STAFF RECOMMENDATION

NCPC File No. 6561

**FORMER WASHINGTON CONVENTION CENTER SITE
INTERIM PARKING LOT
900 9th Street, NW, Washington, D.C.**

March 31, 2005

Illustrative Plan

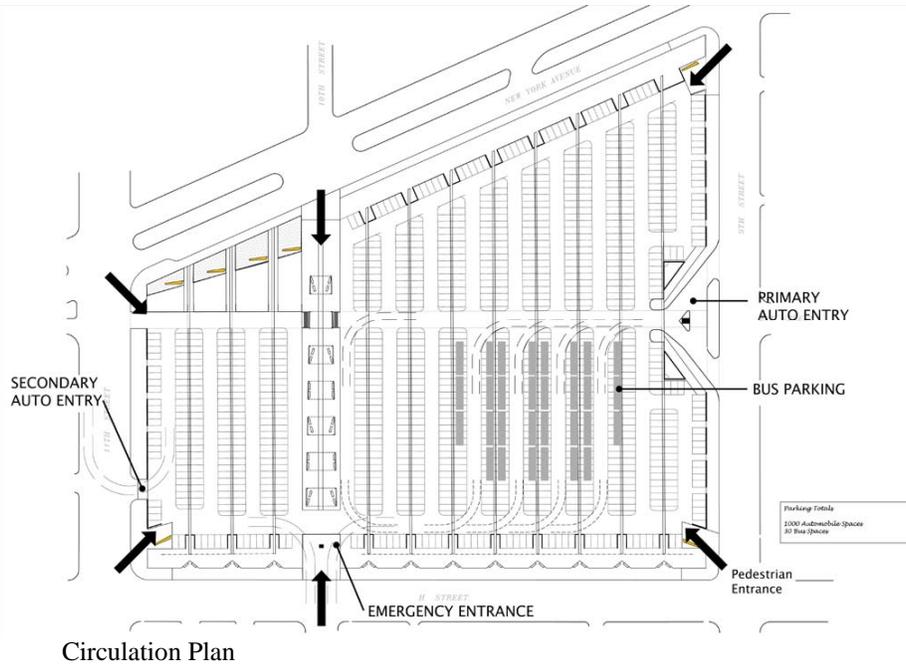
- Additional information has been provided which gives more details of the art corridor including material samples. The principle issue previously raised by staff was the use of artificial turf along the art corridor. Staff preferred the use of natural plant material that would be more compatible with the use of natural plant material along New York Avenue and H Street. However, the natural plant material that would be used along New York Avenue and H Street would not be walked upon by pedestrians, whereas the art corridor is the primary north/south pedestrian path through the site. WCCA advises that programmatically, this area needed a surface and materials that would maintain color, withstand heavy pedestrian traffic, provide a seating area and require minimum maintenance. The use of synthetic turf meets the criteria, therefore, staff is accepting of the use of this material along the art corridor.

- The color palette for the surface of the parking lot has been modified in a manner that now only uses one color to demark the parking spaces rather than the multi-colored approach indicated in the concept plans. Also, two separate colors are used to mark vehicle circulation areas. Staff feels that this approach would “read” more clearly and be less visually intense than the previous submission.
